**PROJECT SCOPING PLAN FOR PERFORMING A CERCLA
REMEDIAL INVESTIGATION/FEASIBILITY STUDY (RI/FS) AT
BUILDING 804 AND THE ASSOCIATED RADIOACTIVE WASTE
BURIAL SITES (SEAD-12) AND THE MISCELLANEOUS
COMPONENTS BURIAL SITE (SEAD-63)**

**PROJECT SCOPING PLAN
REMEDIAL INVESTIGATION/FEASIBILITY STUDY
AT SEAD-12 & SEAD-63
SENECA ARMY DEPOT ACTIVITY
ROMULUS, NEW YORK**

**Parsons Engineering Science, Inc.
Prudential Center
Boston, Massachusetts**

**FIGURE 3-11
GROUNDWATER ELEVATION MAP**

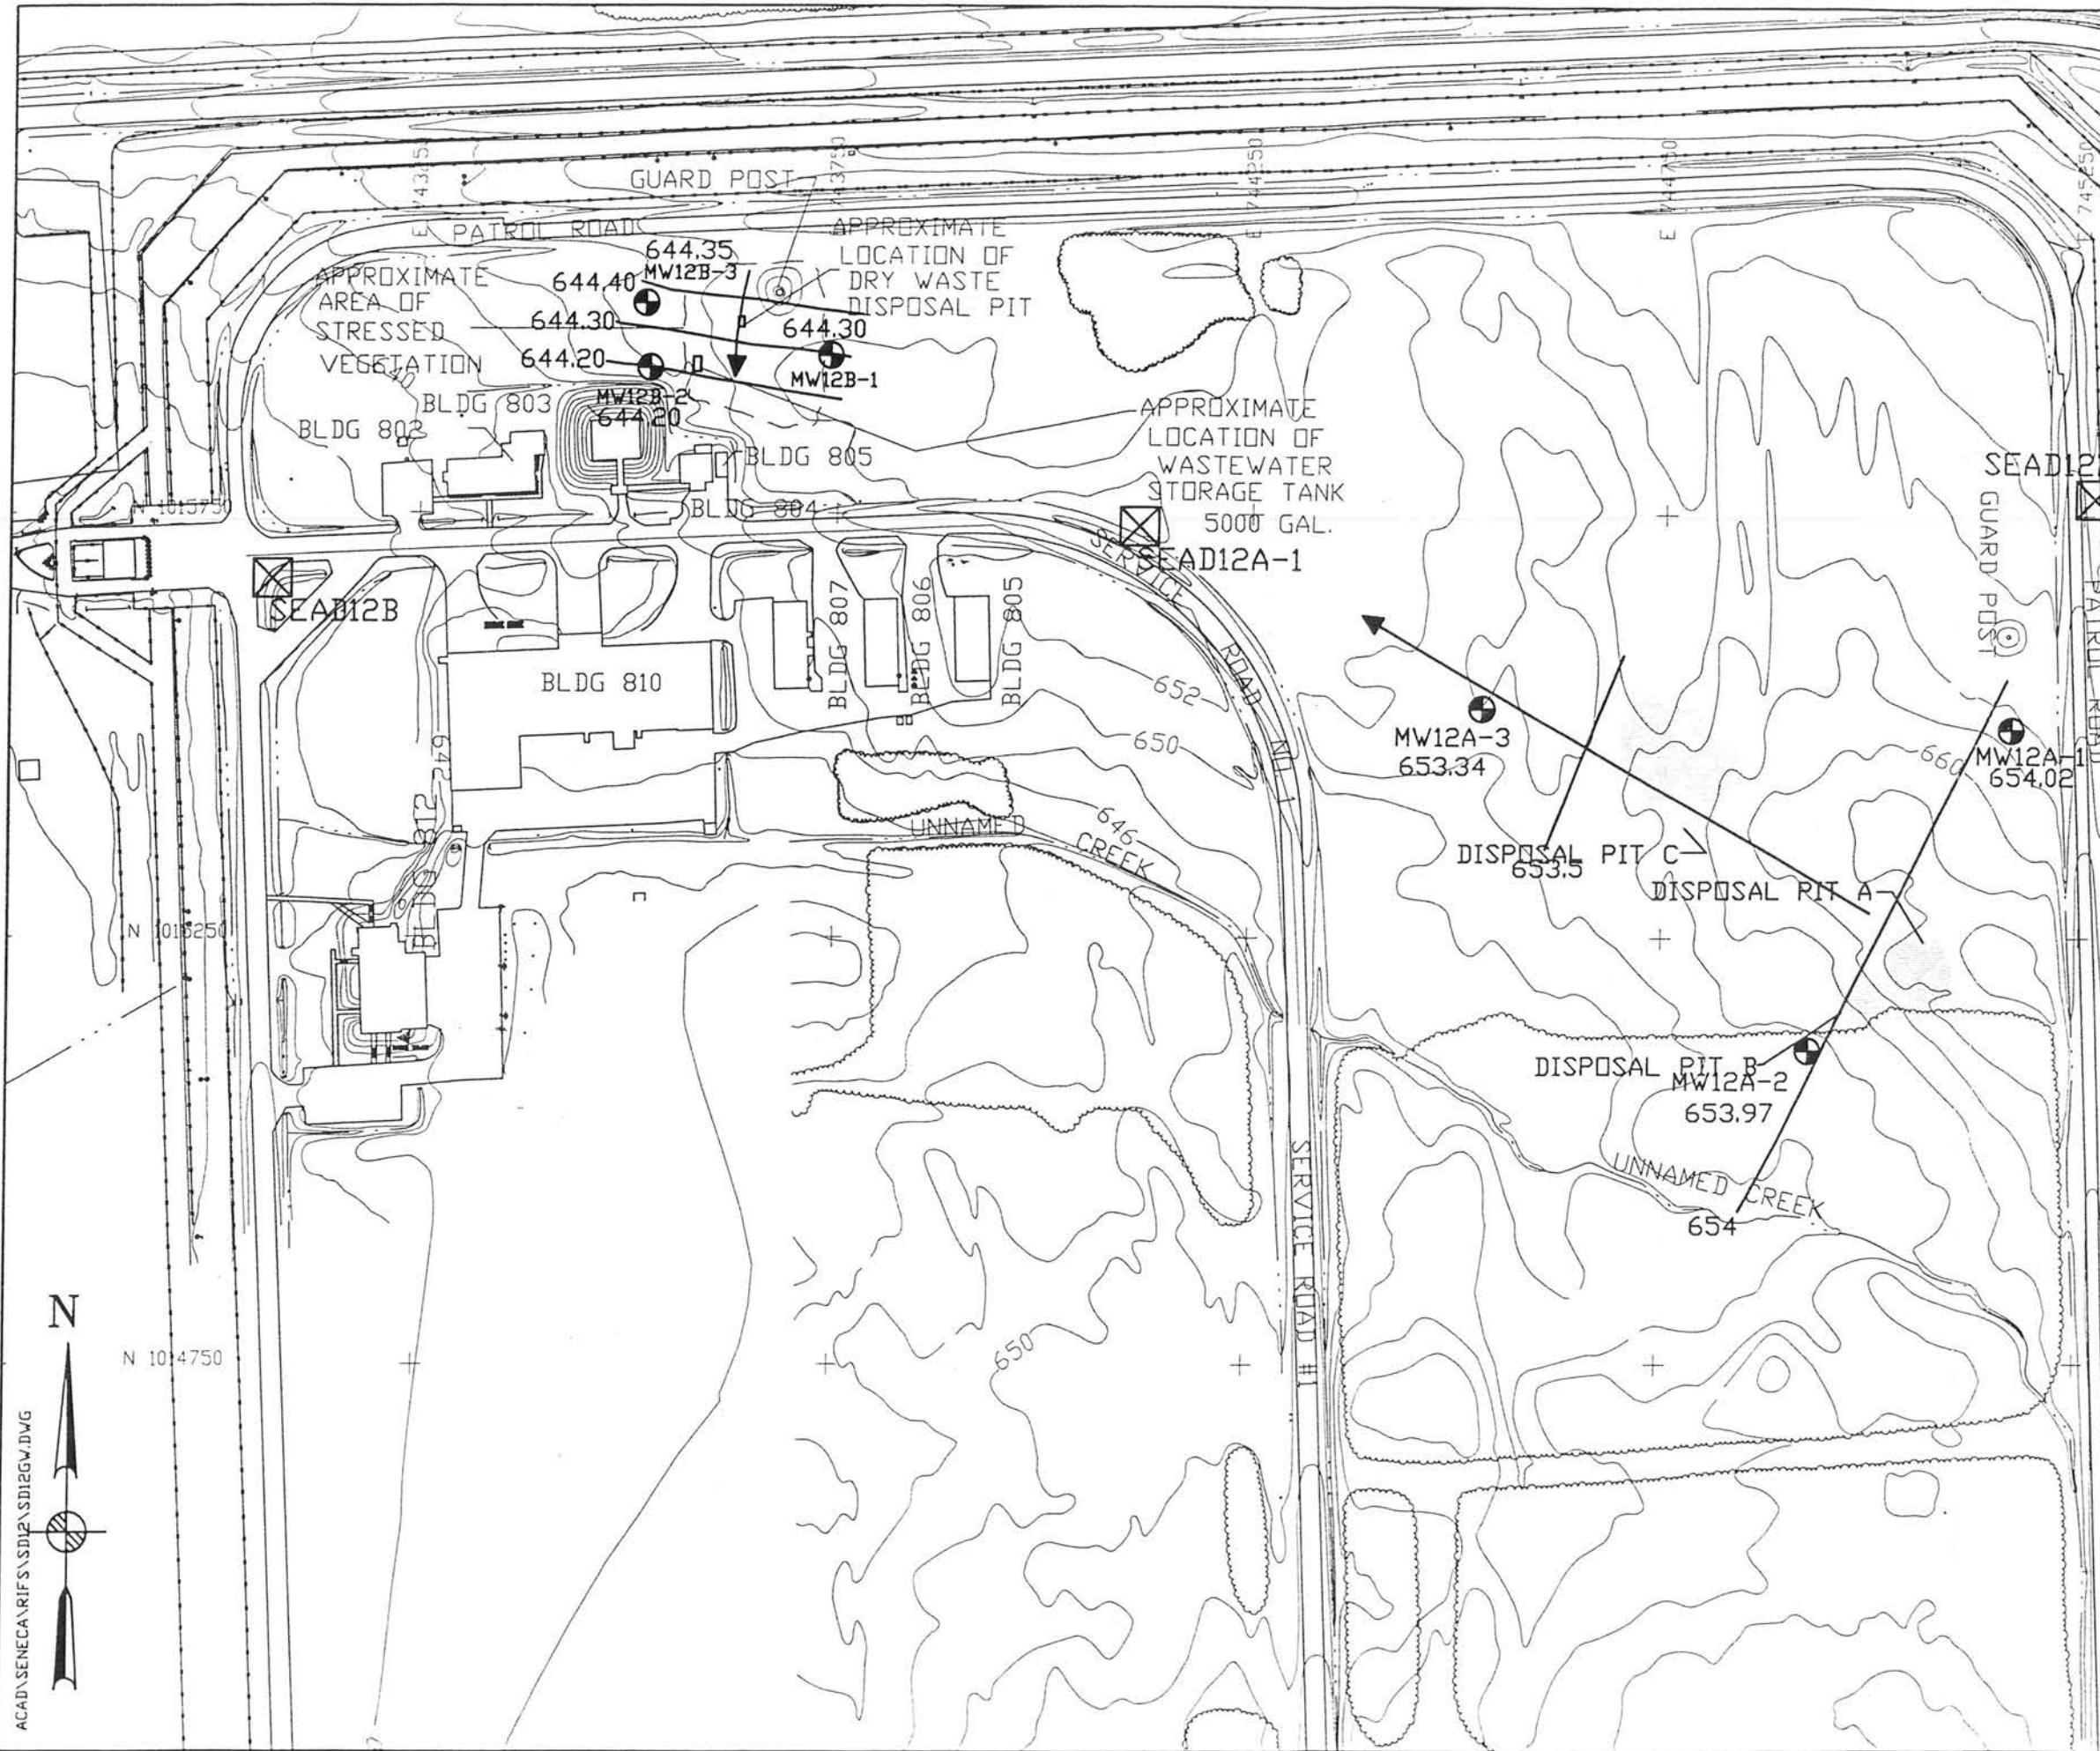
- Comment #5** **Figure 3-11:**
The date for water level measurements does not match that presented in Table 3-2. This discrepancy should be corrected.
- Response #5** Agreed. The date for water level measurements should be July 6, 1994; the date has been corrected in the figure.

The locations of the stated borings/monitoring wells should be checked against Plate 4-1, e.g. MW12-9 appears to be downgradient and not upgradient of the stated location, MW12-12 is not located near the disposal pits. The Army should review the groundwater flow map presented on Figure 3-11, since the stated flow directions in this section do not match Figure 3-11. This discrepancy should be corrected.

area of the site are different. The groundwater flow direction shown in Figure 3-11 is to the northwest and the assumed direction used for monitoring well locations was a radial flow following the ground surface contours. The groundwater flow direction presented in Figure 3-11 was based on data from three monitoring wells, which are not enough data points to accurately depict the groundwater flow direction. In addition, the groundwater elevations in the three wells differs by only 0.68 feet, which does not indicate a strong gradient in any direction. Generally the groundwater flow direction at SEDA is consistent with the ground surface elevation. The ground surface contours and the presence of the unnamed stream south of the disposal area indicate that the groundwater may flow radially from the topographic high near monitoring well MW12A-1 toward the unnamed stream and toward the west following the ground surface contours. This explanation has been added to the text on page 4-12.

| FIGURE 3-22 EXPOSURE PATHWAY SUMMARY FOR SEAD-12 | |

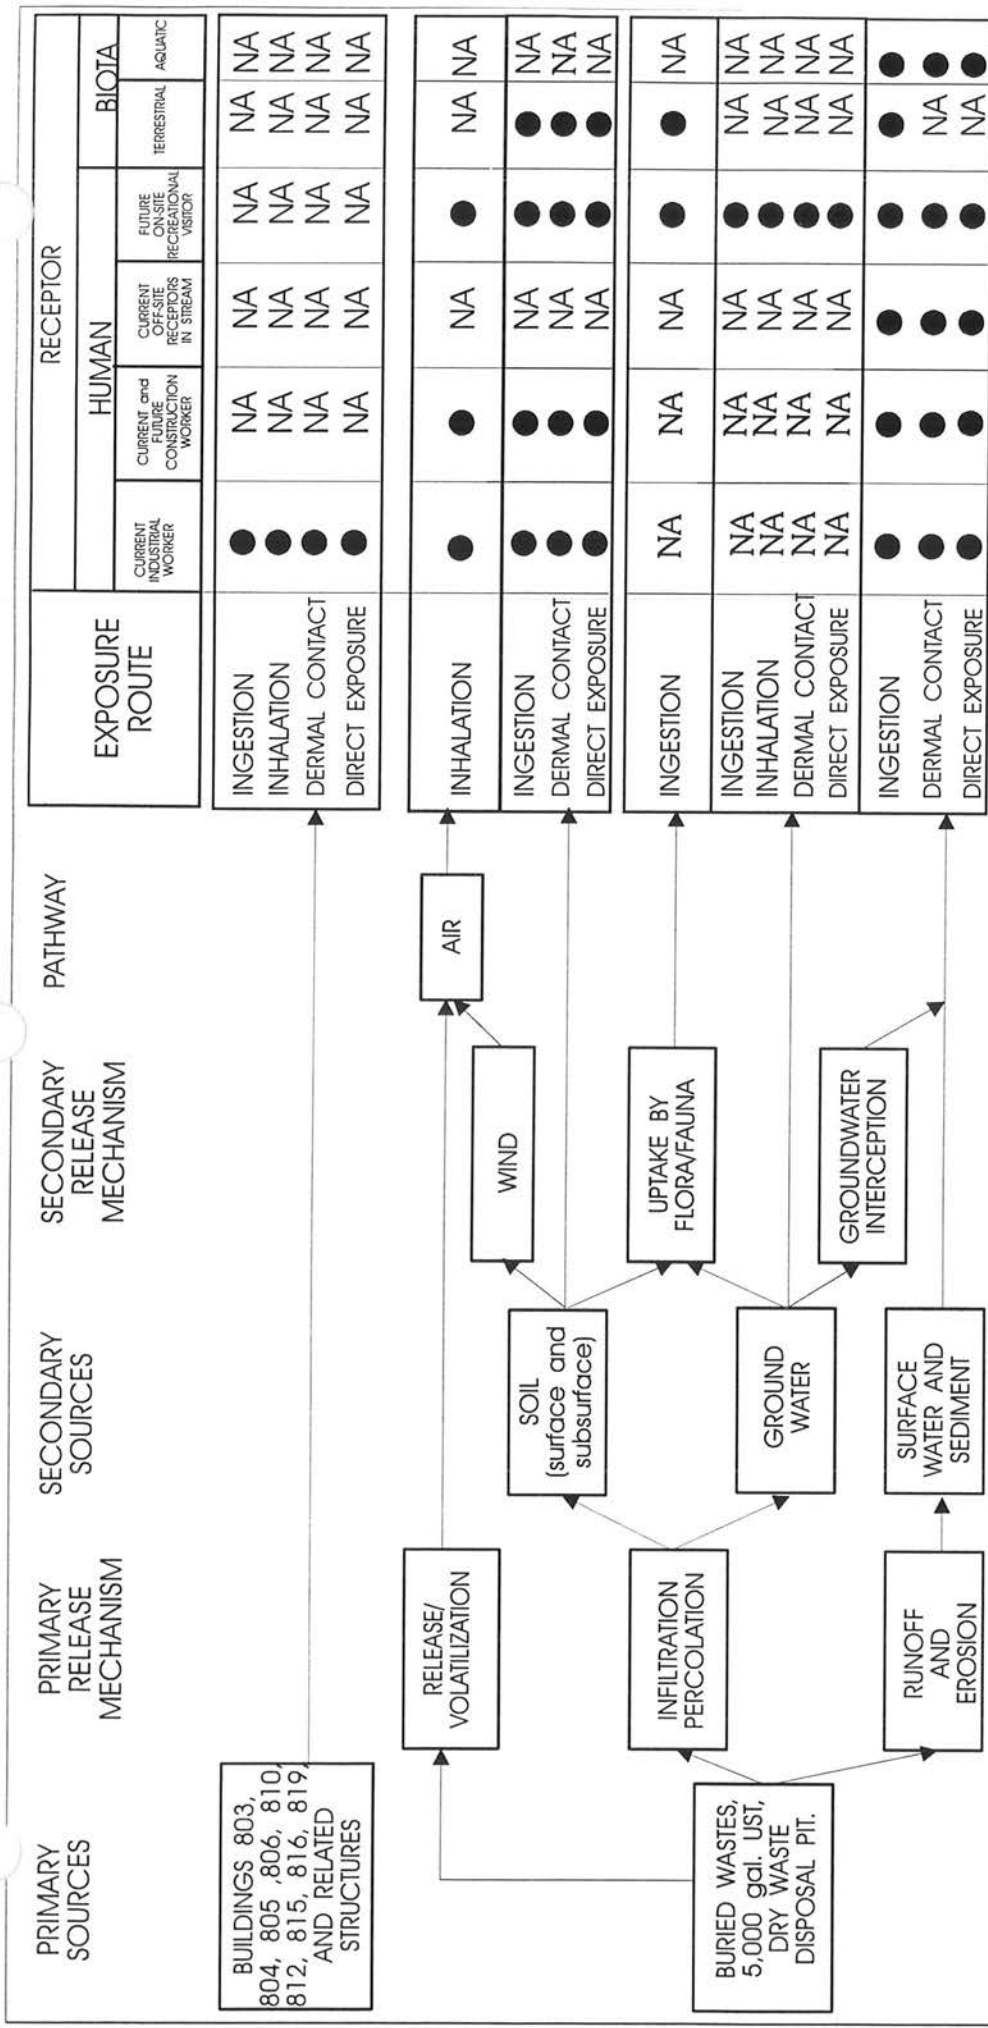
Comment #9 **Figure 3-20, Figure 3-21, Figure 3-22:**
Since radon gas may emanate from sources on the sites, "volatilization" as a primary release mechanism should be revised to "release/volatilization". Since exposure via radon gas, contaminated particulates, and volatilized chemicals may be possible "dust/radon" as a pathway should be revised to "air". Since the text discusses uptake by both flora and fauna, "uptake by flora" as a secondary release mechanism should be revised to include both.

Comment #10 **Pages 3-115, p3; 3-118, p4; and 3-121, p3:**
For consistency with Figures 3-20, 3-21, and 3-22, respectively, site visitors and aquatic biota should be added to the list of receptor populations.

FIGURE 3-23
 EXPOSURE PATHWAY SUMMARY
 FOR SEAD-63

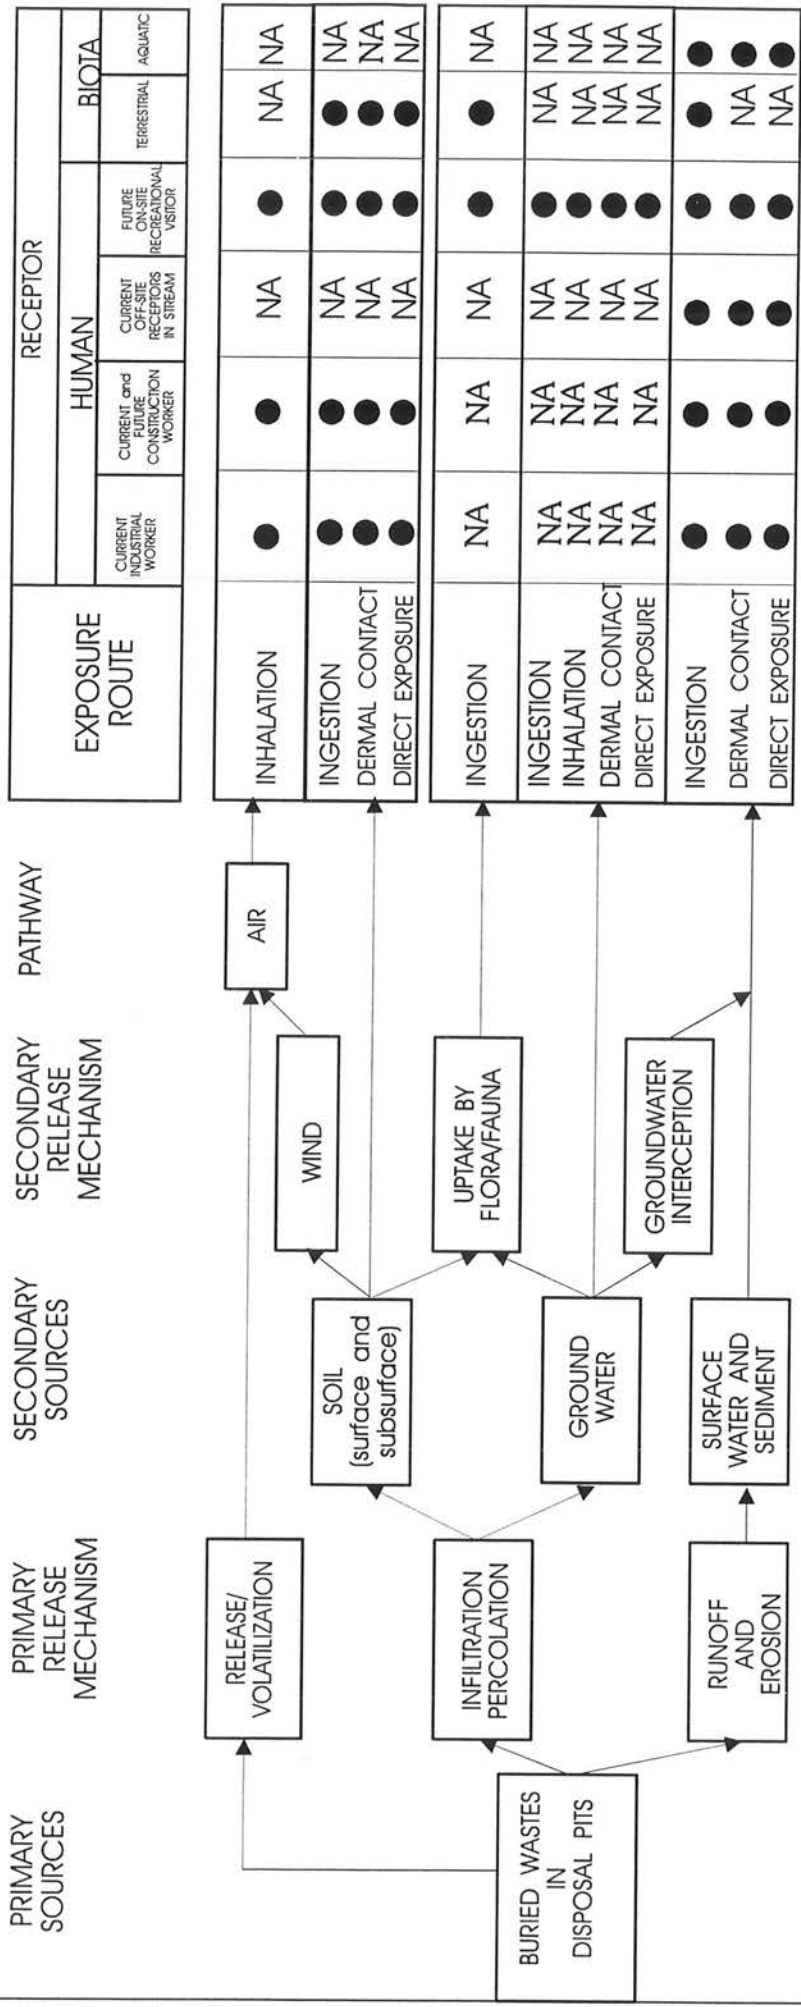
Comment #11 **Page 3-116, p2:**
Since the unnamed creek "eventually flows beyond the AOC boundary and into Reeder Creek" and since Reeder Creek flows off SEDA, consideration should be given to the potential for exposure of individuals who may contact Reeder Creek downstream of SEDA. The potential for impacts to aquatic biota that inhabit the unnamed creek and Reeder Creek should be addressed. According to Section 4.2.10, surface water and sediment samples will be collected from Reeder Creek at off-site locations. Figure 3-20 should be revised accordingly.

- Comment #14** **Page 3-119, p3:**
Since Silver Creek “flows . . . beyond the site boundary and eventually drains into Indian Creek”, consideration should be given to the potential for exposure of individuals who may contact Silver Creek and Indian Creek downstream of SEDA. According to Section 4.3.9, surface water and sediment samples will be collected from Silver Creek and Indian Creek. Figure 3-21 should be revised accordingly.

Comment #3 Figure 3-20 and Figure 3-21: In addition to ingestion, inhalation, and dermal contact, the potential for "direct exposure" should be added as a possible exposure route for radionuclides.

- Response #7** See response to EPA comment #17, dated April 9, 1997, above.
- Comment #8** Figure 3-20 and Figure 3-21: In addition to ingestion, inhalation, and dermal contact, the potential for "direct exposure" should be added as a possible exposure route for radionuclides.
